# MANUAL ADDENDUM

MANUAL # 0901216

# **UMP-200 SERIES**

#### **OVERVIEW**

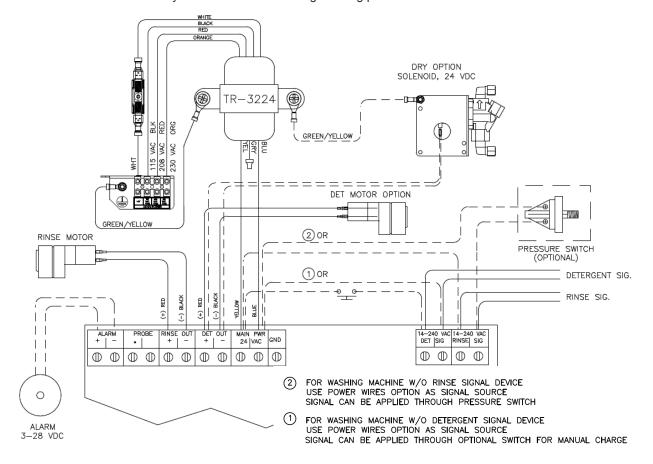
The purpose of this addendum is to inform you of a change to the main power wiring that is not covered in current versions of the following instruction manuals:

The change in the main power wiring is the addition of a terminal block and fusing that upgrades the dispenser to comply with CSA requirements. This only affects the main power connection and signal connections do not change.

- (1) Check the voltage of the main power source and make sure that it matches one of the three available input voltages (115/208/230 VAC).
- (2) Remove all power from the dishwasher.
- (3) Connect leads from the main power source to the appropriate terminals on the wiring barrier (live wire needs to be hooked up to the WHT HOT terminal and the neutral to the BLK 115 VAC terminal for a 120V set up).
- (4) Connect a ground wire from an appropriate ground connection at the main power source to the earth ground terminal on the metal wiring barrier bracket. Use a ring terminal on the ground wire and ensure that both ground wire terminals are securely fastened on the bracket grounding post.
